SERVICE BULLETIN

DATE: 23 JANUARY 2006

TAIL ROTOR BLADE ABRASION STRIP TAP TEST AND MODIFICATION

* Supersedes SB369H-246, SB369D-203, SB369E-097, SB369F-082, dated 5 January 2006.
This revision adds additional tail rotor blade assemblies.

Figure 1. Tail Rotor Blade Abrasion Strip Inspection

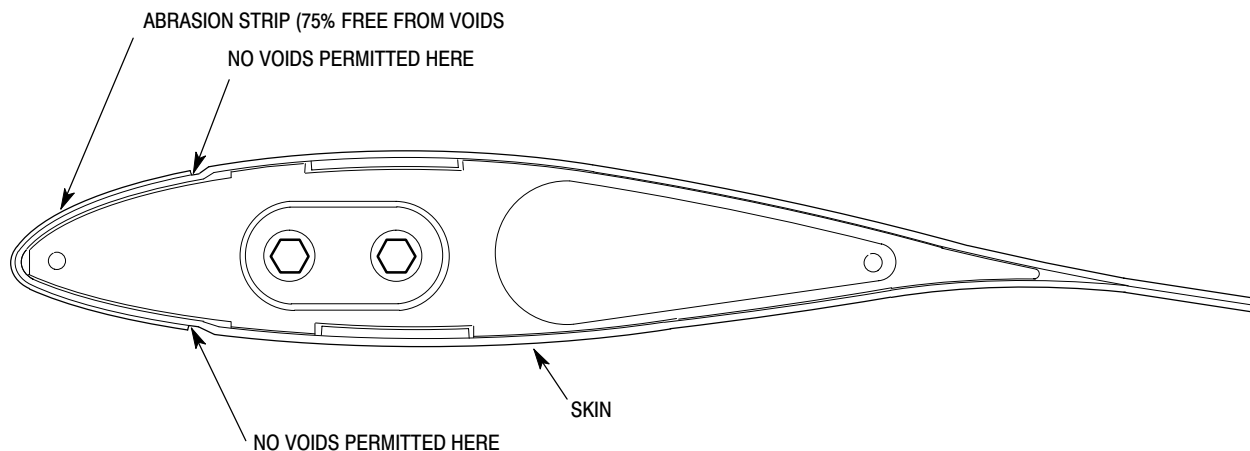
- (1). Perform a tap test on both upper and lower surfaces of abrasion strip surfaces on each tail rotor blade as follows:
 - (a). The tap test may be conducted using a coin (U.S. 25 cent piece or equivalent) or a small brass, mild steel or aluminum hammer.
 - (b). Lightly tap abrasion strip area as shown (Ref. Figure 1). Tap in a pattern with no more than 0.13 inch (3.30 mm) between taps in any direction.

NOTE: A void will produce a tone change. The tone will be lower over the void. A method of "tuning" your ear is to tap from the leading edge of the blade toward the trailing edge. As you move past the aft edge of the abrasion strip and over the skin, you will notice a distinctive lowering of the tone produced.

- (c). Inspect (tap test) abrasion strip to skin bond from inboard end of blade to blade tip in spanwise direction and from leading edge to aft edge of abrasion strip in chord-wise direction.
- (d). Allowable void size in abrasion strip area is 0.2 square inch (5.08 square mm). There shall be 1.0 inch (25.4 mm) between voids in this area.
- (e). Seventy-five percent of the abrasion strip bonded area shall be free from voids, except that no voids shall break out to the edges of the abrasion strip. The upper and lower surfaces shall be considered separately.

- (2). Remove from service any tail rotor blade that does not meet the above inspection requirements.
